Interactive comment on “Structural geology and geophysics as a key to build a hydrogeologic model of granite rock to support a mine” by L.Martinez Landa et al.

P. Hsieh (Referee)

Received and published: 21 March 2016

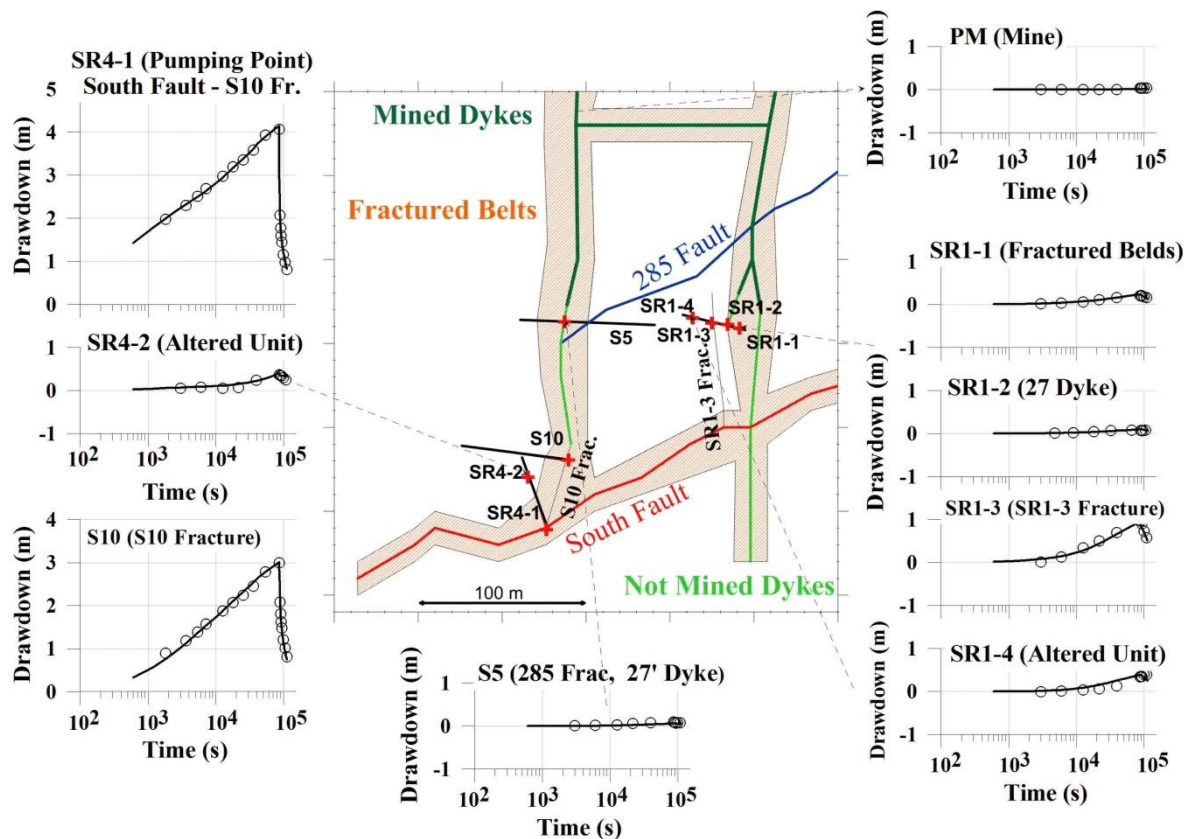
The fractures shown in Figure 11 (blind prediction) appear to be the same as the features shown in Figure 9 (calibration).

It has been an error in the Fig 9. We modify the Figure 9 as follows:
